# CITY OF ALBUQUERQUE

RE: **File/Gul Development**  
**Grading and Drainage Plan**  
**Engineer's Stamp Date 1/25/18**  
**Hydrology File: G13D033**

Grading and Drainage Plan

C100

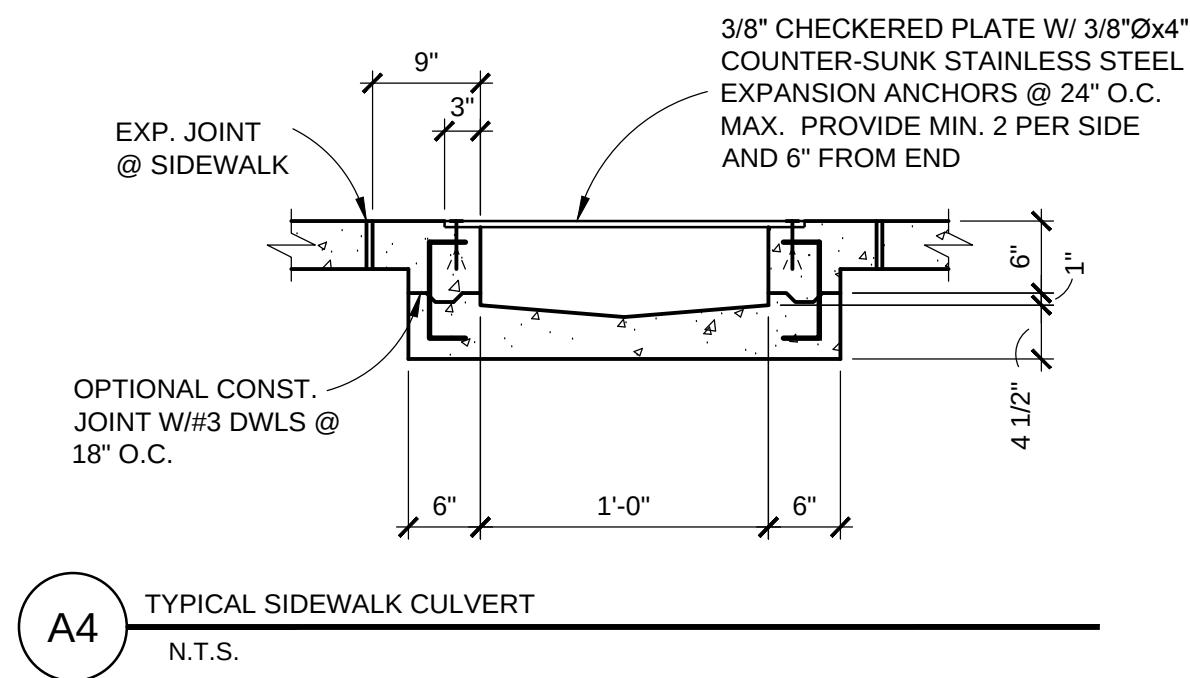
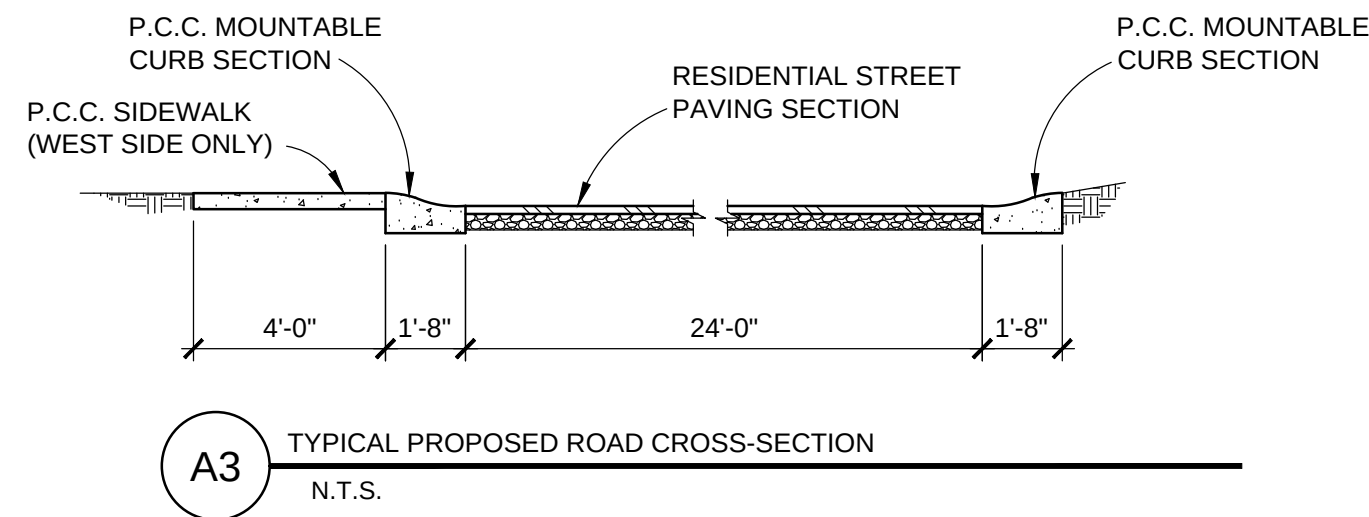
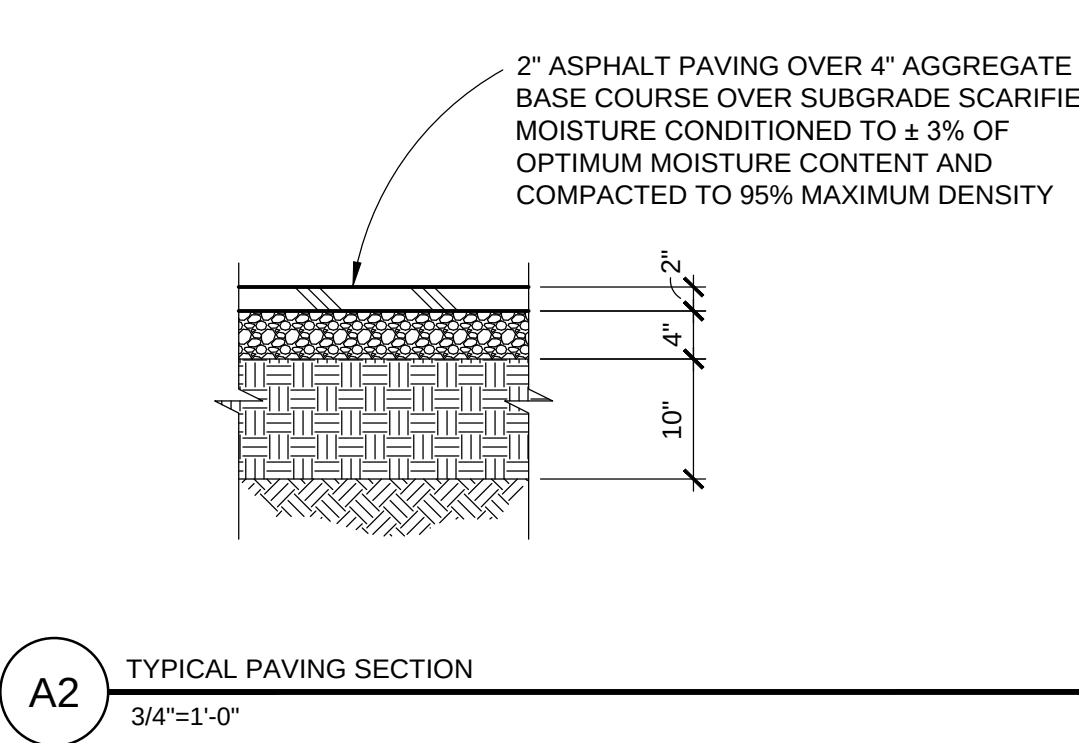
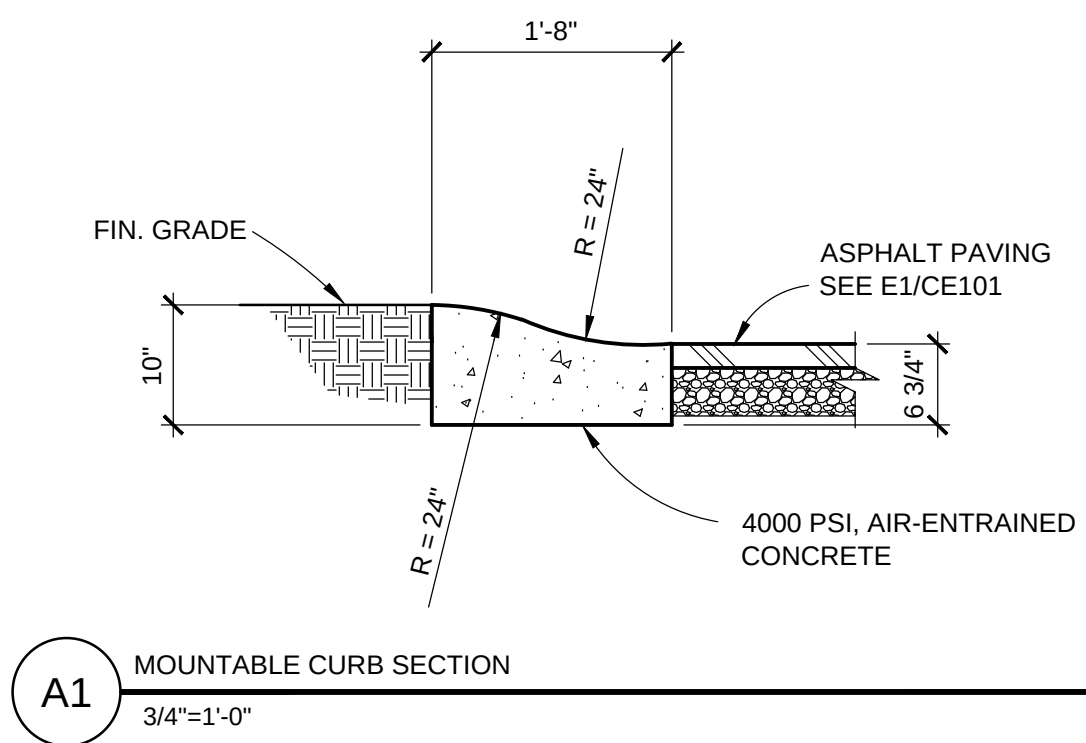
Based on the information provided in your submittal received 1/25/18, the Grading and Drainage Plan is approved for Preliminary Plat (infrastructure list) and Grading Permit.

On the Plat, add a blanket (exclusive of buildings) cross-lot drainage easement for all three lots to support this drainage scheme.

1. Three Private Facility Drainage Covenants are required for the ponds, one for each lot. The original notarized forms, exhibits, and recording fee (\$25/ea, payable to City of Albuquerque) must be turned into DRC (4th, Plaza del Sol) for routing. Please contact Charlotte LaBadie (clabadie@cabq.gov, 924-3996) or Madeline Carruthers (mtafoya@cabq.gov, 924-3997) regarding the routing and recording process for covenants.
2. On the exhibits for the covenants, label each pond and include bottom of pond, top of pond, and required volume. Ensure all text is legible (0.10" or larger) and the exhibit is printed on 8.5x11.

3. Pad Certifications (or Release of Financial Guarantee) will be required prior to Hydrology approving the residential Building Permits.

4. Engineer's Certification, per the DPM Checklist, will be required to ensure the ponds remained intact following home construction.

5. The Drainage Covenants must also be recorded with Bernalillo County and a copy included with the Certification.
